Proposed Changes to the England Coast Path at Nethertown and Sellafield, Cumbria

Natural England's Variation Report to the Secretary of State

Coastal Access Variation Report VR7
26th June 2019

2.4 Proposals Map

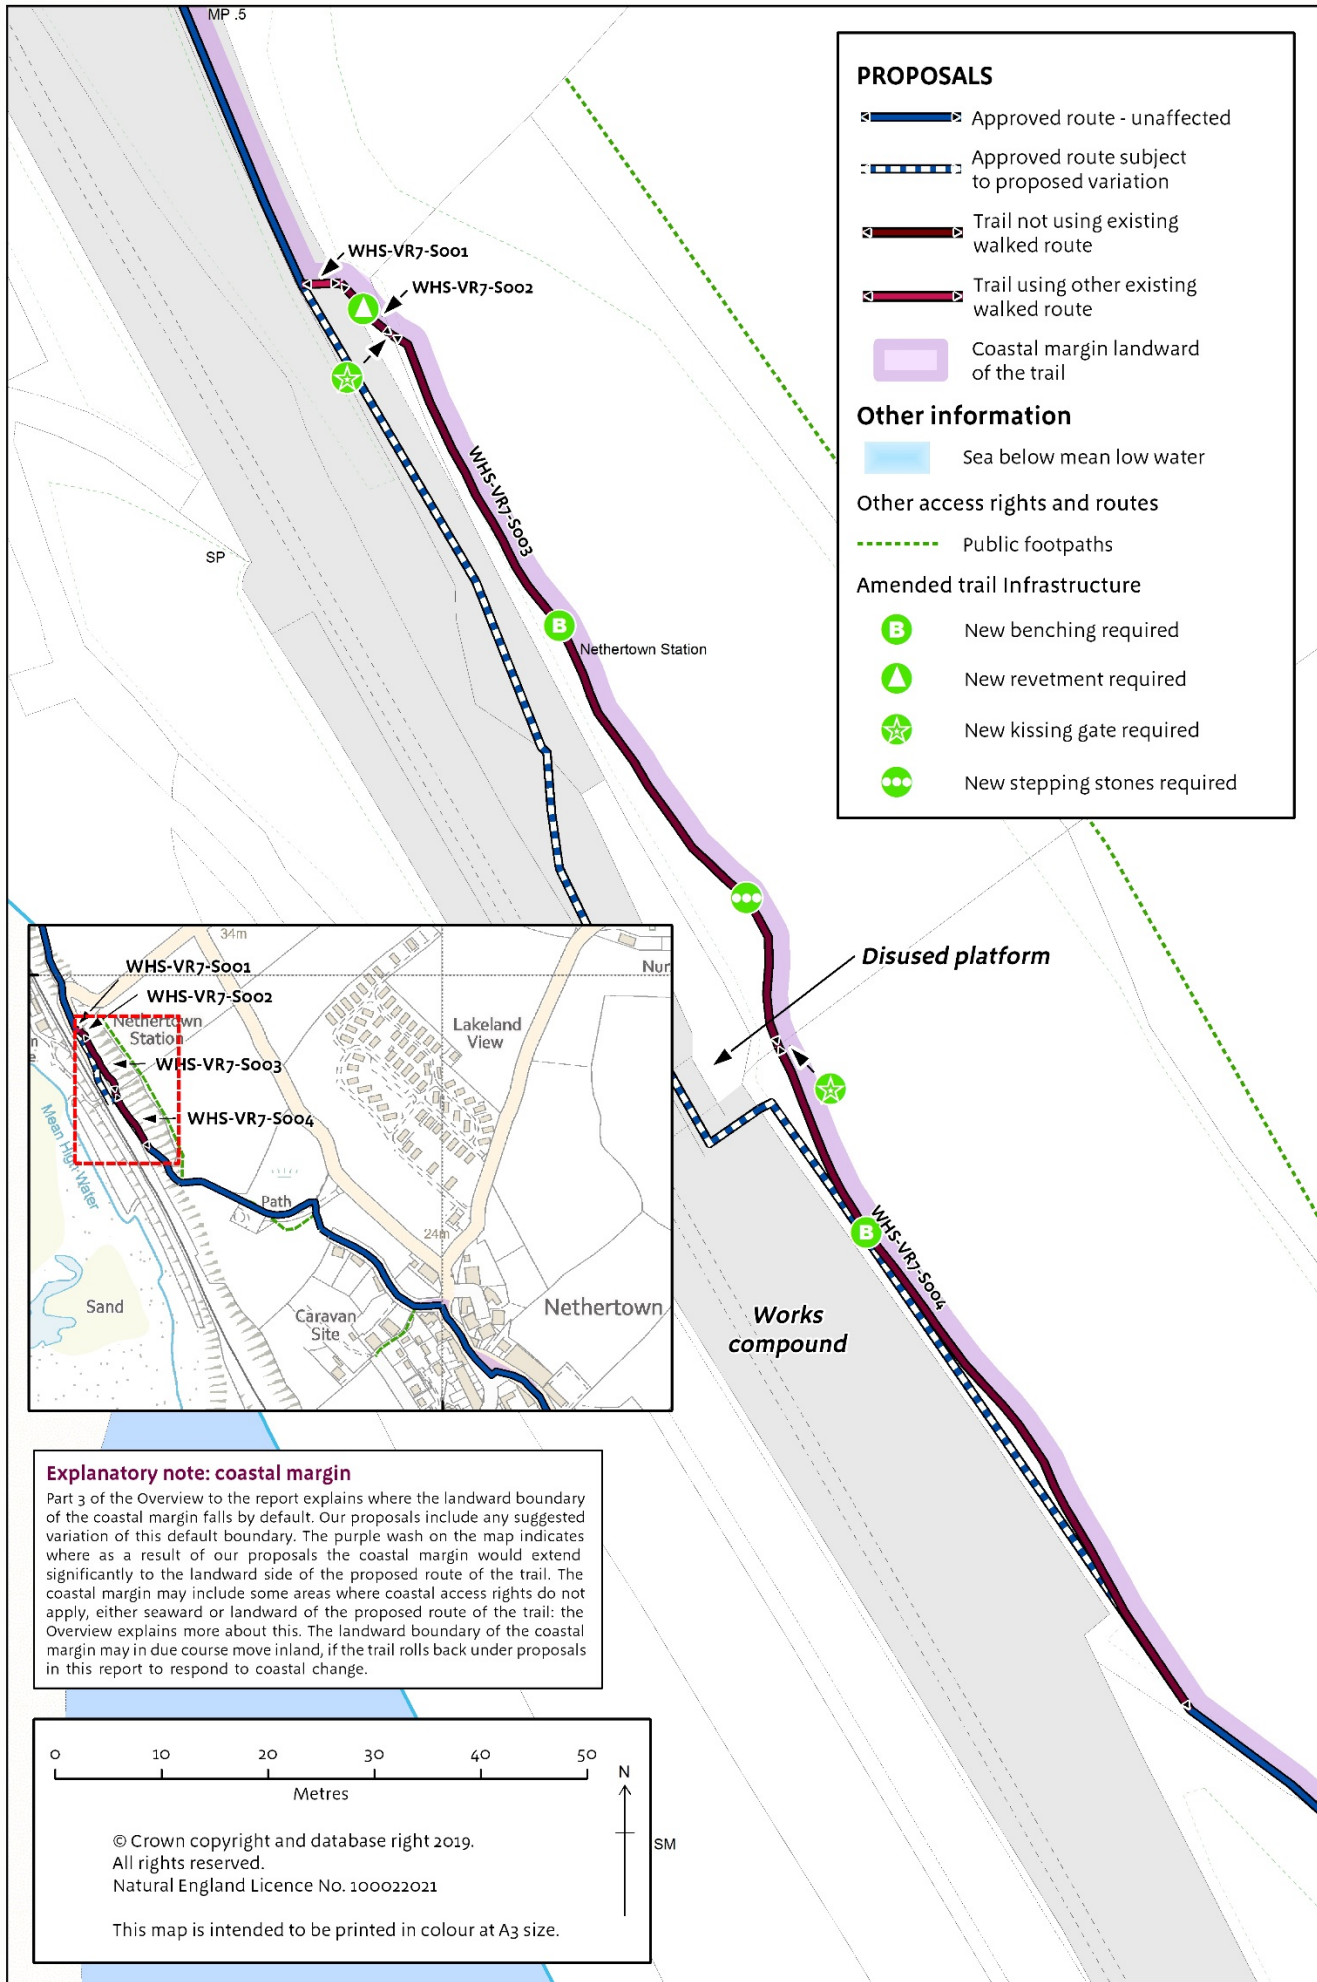
2.1.1 Network Rail (NR) supported the route we originally proposed, at and around Nethertown station. On that basis it was approved by the Secretary of State. The proposed route lay immediately landward of the boundary fence around NR's works compound, adjacent to the southern end of the railway platform at the landward side of Nethertown station. It entered NR land at the north-eastern corner of this compound, before passing along the disused platform. We proposed this route originally on the grounds that it met all the main requirements within the approved Coastal Access Scheme and was an existing walked route (thus apparently avoiding the need to create a new route in the area).

2.1.2 However, there has been some change of situation locally. During more recent discussions with NR around trail establishment, it has become apparent that:

- The fence on the landward side of the works compound has been replaced on a slightly different alignment, meaning that the approved route now sits partially within the compound rather than entirely landward of it.

- This area, next to the disused station platform, is now more actively used as a fenced NR storage compound, and contains various hazards on or adjacent to the approved route that were not previously present.

- NR is now taking a more risk averse approach to access through the compound and along the raised, disused station platform, which is now used for NR vehicle access to the adjacent works compound. NR would now insist on expensive new infrastructure such as safety barriers being installed there as a condition of any route establishment. In fact, there is insufficient space on the disused platform (and above the underpass in particular) to accommodate the ECP alongside any vehicle movements, whilst maintaining public safety. As a result, NR feel the approved route as a whole is incompatible with their operational and safety requirements.

2.1.3 Aside from this issue of impracticability we are advised by NR that, should work proceed to establish the approved route on the ground, these works would cost in the region of £100,000. This is a broad estimate only – exact figures could only be

2.2.1 Our proposal (see map VR7a) is to re-route the path to the landward side of the current compound fence, disused station platform and underpass, at the bottom of the coastal slope (proposed route sections WHS-VR7-S001 to WHS-VR7-S004). The realigned trail would extend to a length of 162 metres, at a maximum of 15 metres landward of the approved route line and would still pass within 50 metres of the station entrance (allowing for easy access to the station as required).

2.2.4 The proposed trail consists of a path with a combination of natural, flagstone and crushed stone surfaces.

3.4 Proposals Maps

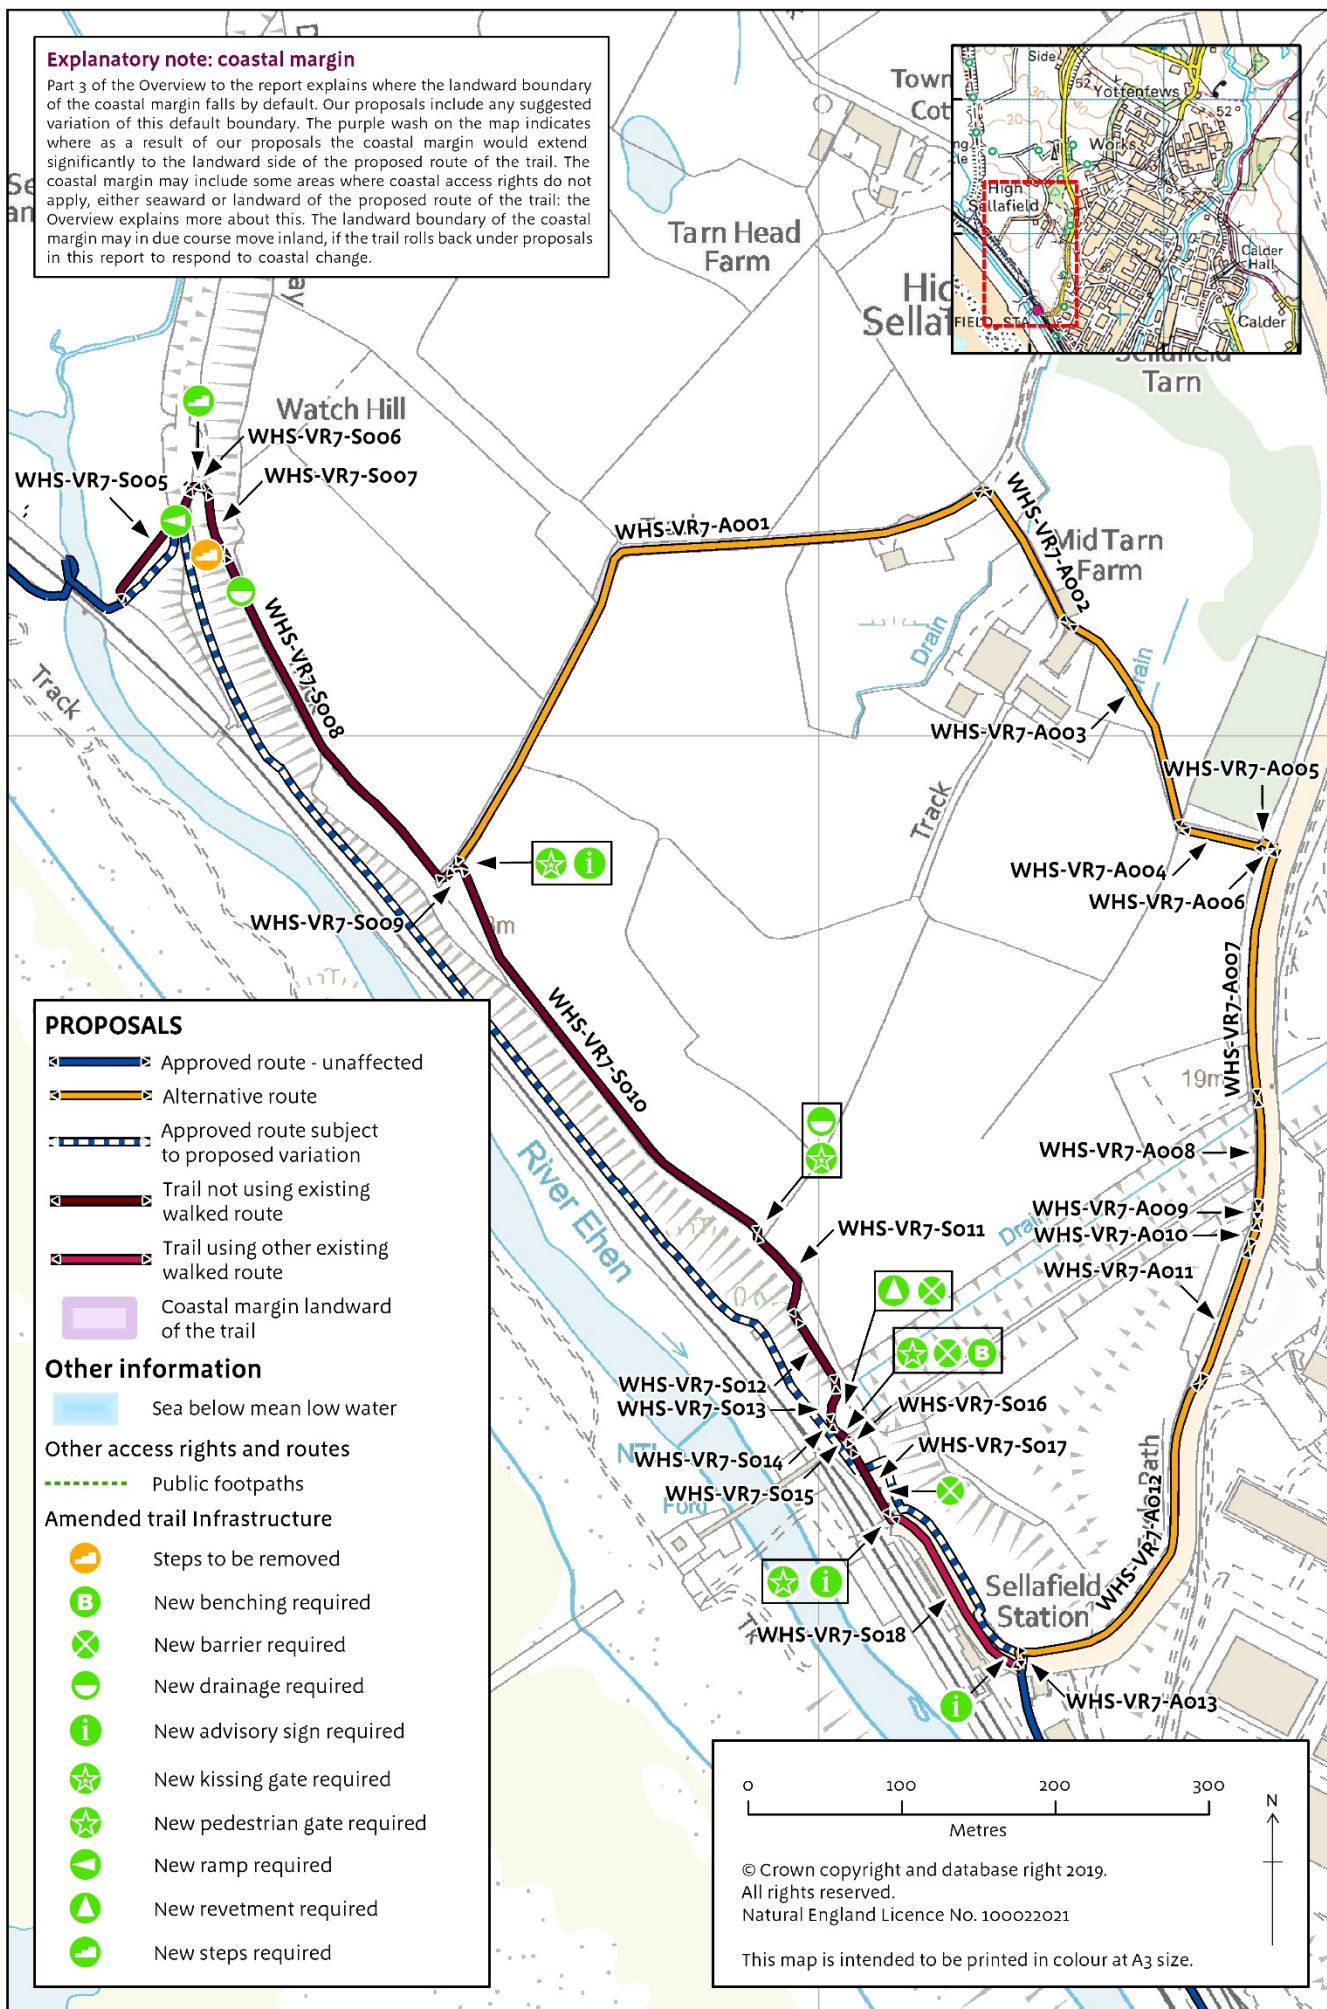
3.1.1 Our original alignment of the ECP in this area, as approved by the Secretary of State, reflected an offer at the time by NR to remove a disused railway siding in order to create a sufficiently wide corridor within which the path could pass and could be fenced off from the active railway line. NR undertook to install this fencing and to undertake themselves the removal of the siding. These works would have segregated the path from the land used for the purposes of a railway, and thereby avoided the path corridor being regarded as excepted land for the purposes of CROW access rights.

3.1.2 However under its new local representation (see above), NR now advises that the siding is being returned to operational use and cannot be removed, which means there is not physically space for the ECP to pass through the corridor in question. Neither are NR willing to provide the required new fence, even if there had been room to do so. The land in question would therefore reasonably be regarded as part of the land used for the purposes of the railway, and therefore excepted land.

3.1.3 It would have been preferable from the outset, in any case, for the ECP to pass instead on the seaward edge of the land that lies at the top of the slope above this 'railway corridor', along a line similar to that of the former Cumbria Coastal Way (CCW). However at the time our original proposals were developed, the whole of that area was part of the proposed construction site for a new Moorside Nuclear Power Station. Given the clear intention to develop the land in this way, but at that stage the uncertainty as to precise layout etc., it would have made no sense for us to propose any specific route alignment across the land in question.

3.1.5 In summary, the route can no longer pass through the ‘railway corridor’ as originally agreed with NR; but it may now pass on the seaward side of the former development site, along a preferred alignment on or close to the original line of an existing promoted route. In the circumstances we are proposing the variation of the approved route onto the latter alignment, as shown on map VR7b.

3.2.1 Our proposal (see map VR7b) is, from north to south, to re-route the path between the Ehen viaduct and Sellafield station, including an alternative route available when the main trail may occasionally be closed for operational reasons (see 3.2.10 to 3.2.14 below). The realigned main trail would extend to a length of 1.08km, at a maximum of 50 metres landward of the approved route.

3.2.2 The proposed route would cross the common from the railway viaduct over the River Ehen, on a slightly different route to the former Cumbria Coastal Way, to avoid using the existing but disused steep flight of steps (proposed route sections WHS-VR7-S005 to WHS-VR7-S007). It would then follow a strip of common land along the top of the slope (section WHS-VR7-S008), before entering an agricultural field at NY017039. Before reaching the Sellafield site itself, the path will exit the field to drop gradually down the slope, passing directly underneath the pipe bridge, then in a

corridor past an existing works compound and on to Sellafield station, where it will join the previously approved route on the existing cycle path to Seascale.

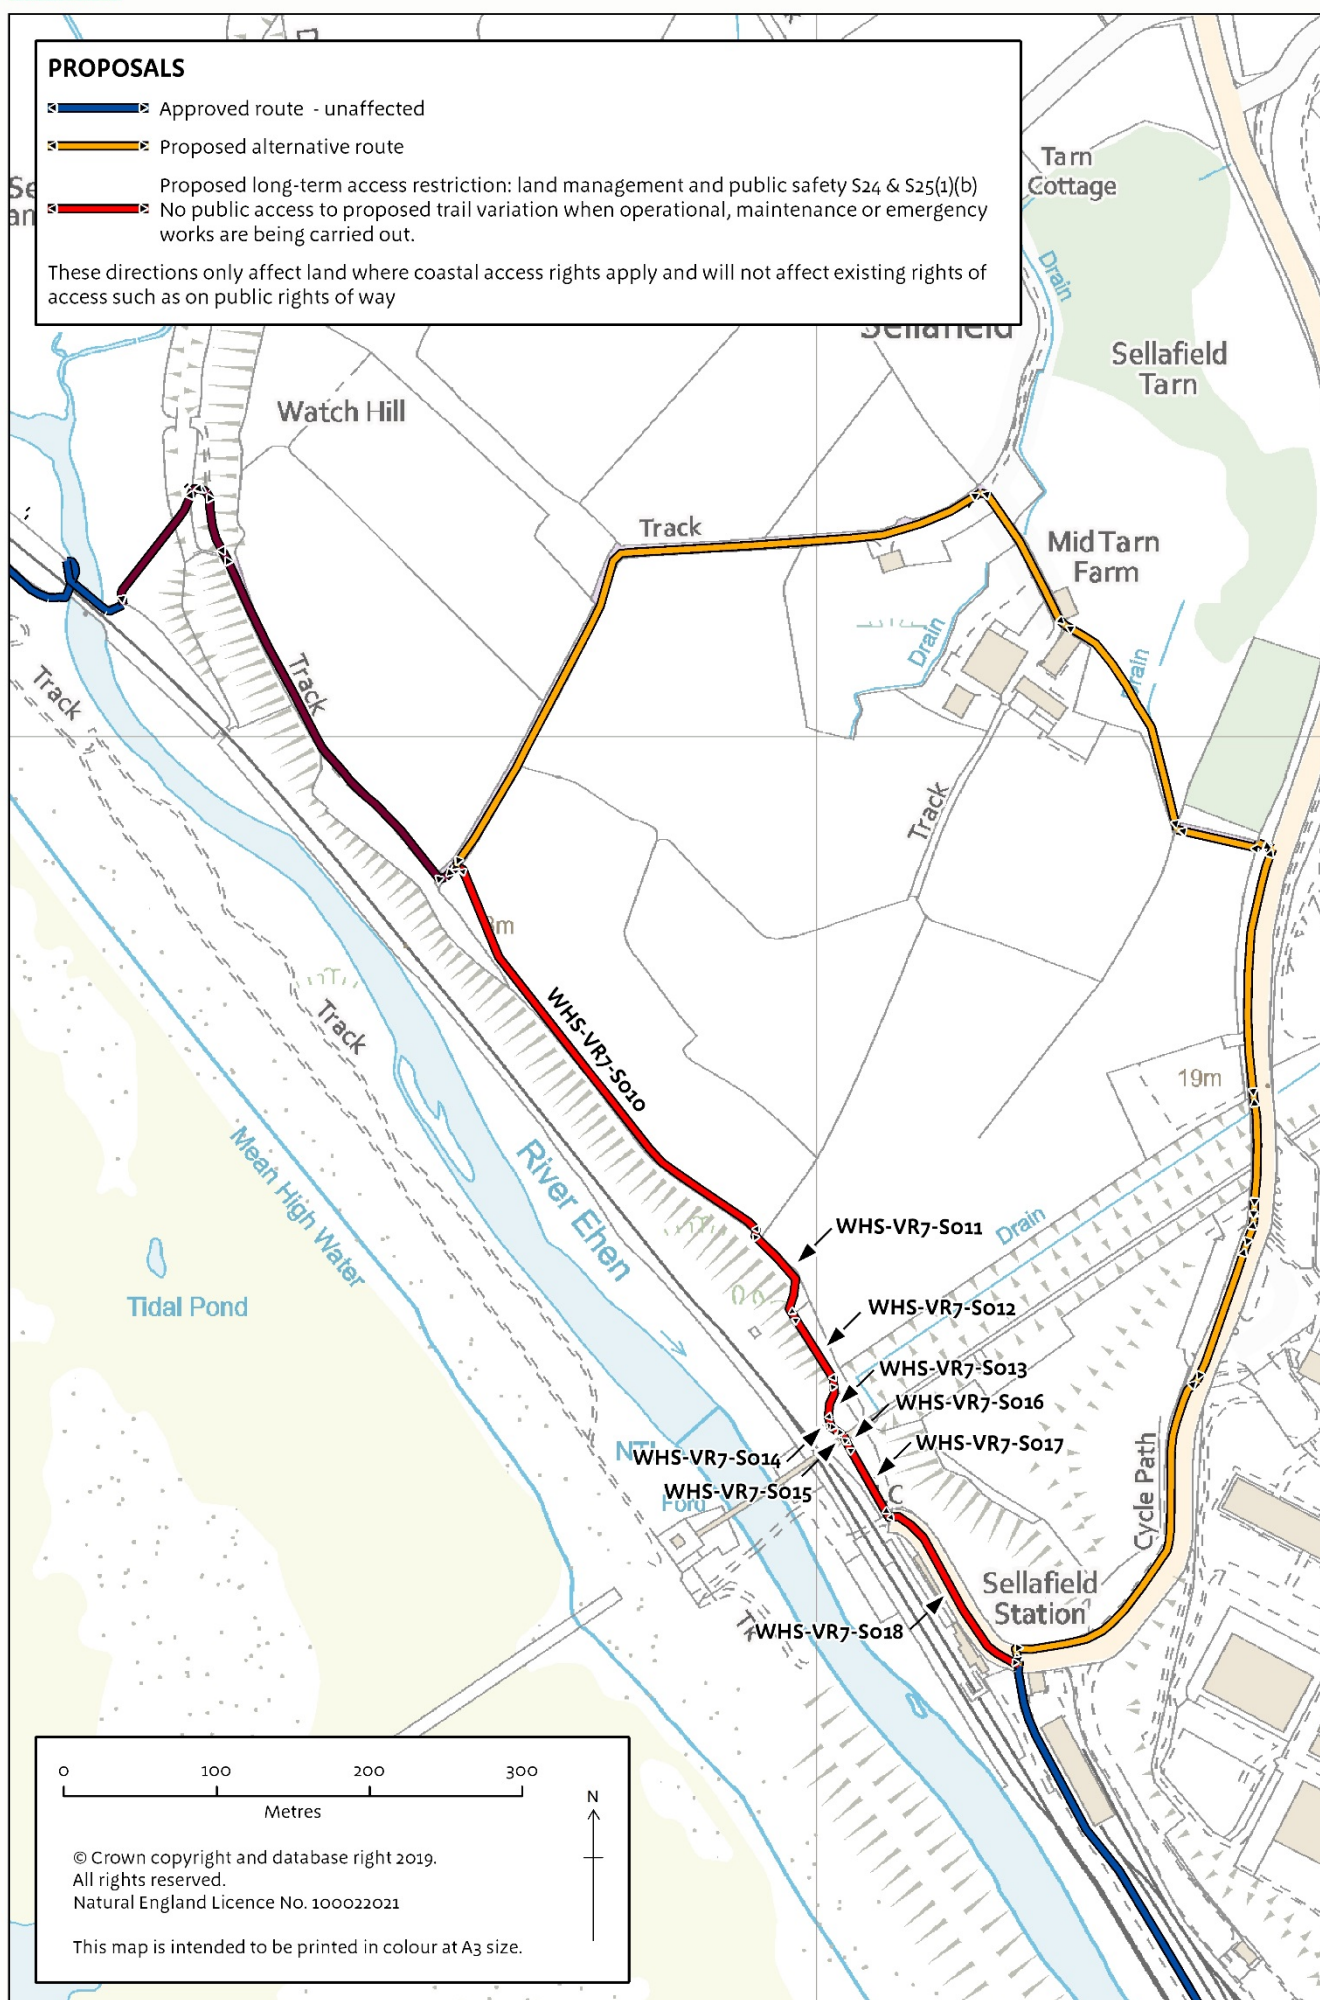
3.2.12 Access to route sections WHS-VR7-S010 to WHS-VR7-S018 is to be excluded by outline direction, under s24 and s25(1)(b) of the Countryside and Rights of Way Act (2000) at times when this is required to enable short-term emergency, maintenance or operational works to be carried out (see map VR7c).

3.2.14 An alternative route is to operate at times when access to route sections WHS-VR7-S010 to WHS-VR7-S018 is excluded under the terms of the outline direction described in paragraph 3.2.11 above. It would be advertised by the site owner/manager with temporary signs. The alternative route is to be at the centre of the line shown as route sections WHS-VR7-A001 to WHS-VR7-A013 on map VR7b. It would not have the effect of creating any additional spreading room on either the seaward or the landward side.
